Staff Report

Re: PLNHLC2020-00940 – Minor Alterations @ 229 N Almond Street

Minor Alteration

REQUEST: Maeli Merrill, property owner, is requesting approval of a Certificate of Appropriateness for the installation of a new dormer and replacement of windows, siding on the rear of the house, front door, and fascia in the front façade. The property is currently under enforcement, as all the requested items have already been installed. The property is located at 229 N Almond Street and is a contributing structure within the Capitol Hill Local Historic District. The property is located within the RMF-35 and RMF-45 zoning districts.

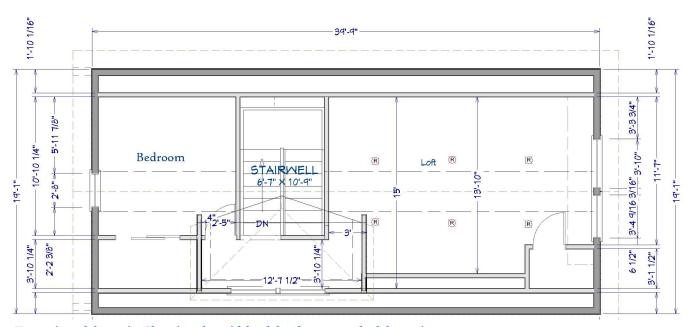
The dormer was built with a pitched roof that does not match the pitch of the house, the pitch on the dormer is a lot flatter in comparison with the pitch of the house. The dormer is very wide and has a horizontal orientation. The roof ridge of the dormer is of the same height as the roof ridge of the house. The siding of the dormer is vinyl and the window on the dormer is a sliding vinyl window.

Staff asked the applicant to consider changing the dormer to better fit the architectural style and the scale of the home. Staff suggested a dormer like the property located just south of this property. Please see photo (left). The applicant responded that they would not be able to reduce the width or height of the dormer because the width and the height are necessary for the landing of the new stairs to meet current IBC standards. The width of the dormer corresponds to the width of the staircase and to the access to the

different spaces in the attic. Staff suggested changing the landing of the staircase. The applicant responded that the staircase is 3 stories high and could not be rotated without the entire substructure needing to be re-engineered.

The proposed hip roof is a positive change because it relates to the roof on the porch of the house and it lowers the height. The proposed changes to the siding and window are also positive. However, staff finds that this dormer, even with the proposed changes, would not be subordinate to the roof and the scale of the home.

However, the dormer as proposed, is not subordinate to the roof and the scale of the home. Therefore, staff does not recommend approval of the dormer, either as built or proposed.

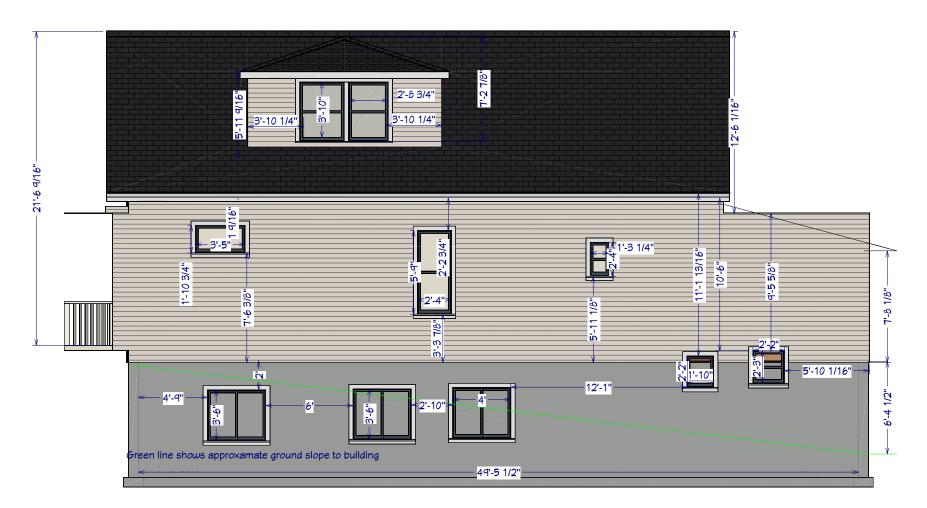
Staff is asking for direction from the commission on whether to approve or deny the dormer.

- 1. Change the roof shape from a pitch roof to a hip roof, to echo the hip roof at the front of the house. That would be in keeping with some of the roofline and would reduce some of the height of the dormer.
- 2. Change the siding of the dormer from vinyl to wood lap siding.
- 3. Change the one vinyl/slider window of the dormer with two double hung wood windows side by side.

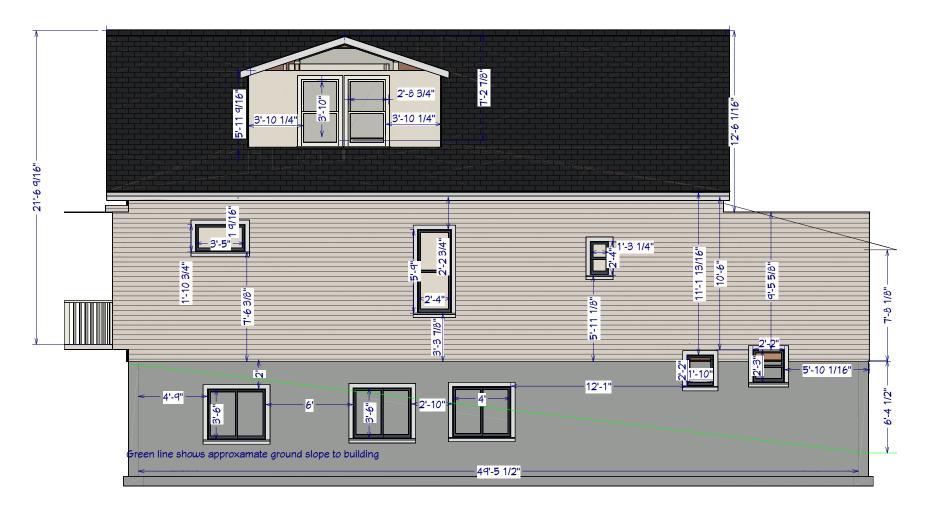
Addition has shed roof , because of sotware limitations I cannot render the roof in this drawing.

Lower elevation is 14' above grade

Upper elevation is 15'7" above grade

The terrain slops from the front of the house at the top of the foundation to completely exposing the foundation wall just before the addition
